December 24, 2020

Industrial Device Business Division,
Industrial Solutions Company
Panasonic Corporation

Notice of Compliance with China Energy Efficiency Label Regulations

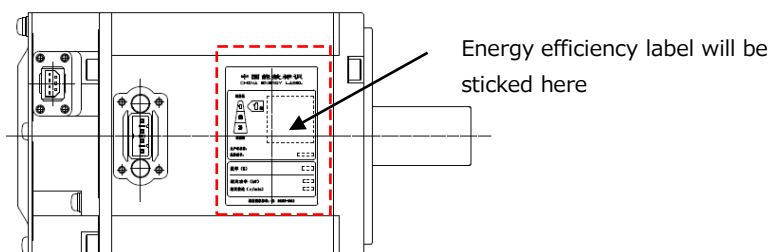
"Even if wrinkles appear on the label attached to the motor, there is no problem in using the product." was added to the safety precautions page in Japanese and English.

Motors with an output of 550 W or more and without a holding brake have a designated label affixed based on the "Energy Efficiency Label Implementation Regulations for Permanent Magnet Synchronous Motors" (CEL 038-2020) "GB30253-2013".

Flange size 100 mm Square or More:

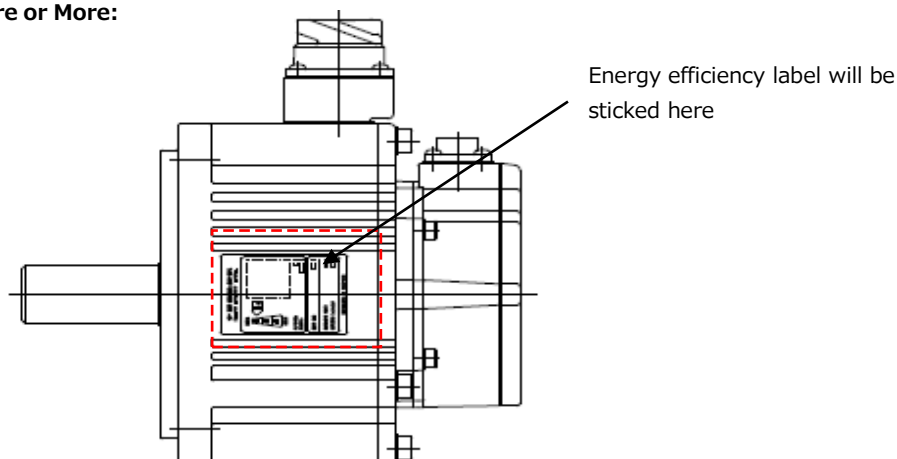
2. Product (motor body): Energy efficiency label will be attached to the motor
[AC servo motor]

Flange size 80 mm Square only:

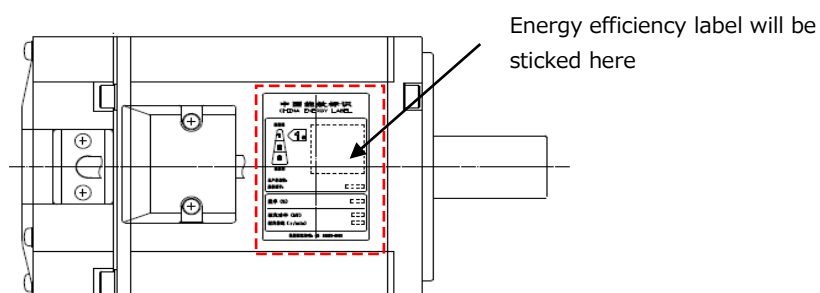
[Brushless Motor]
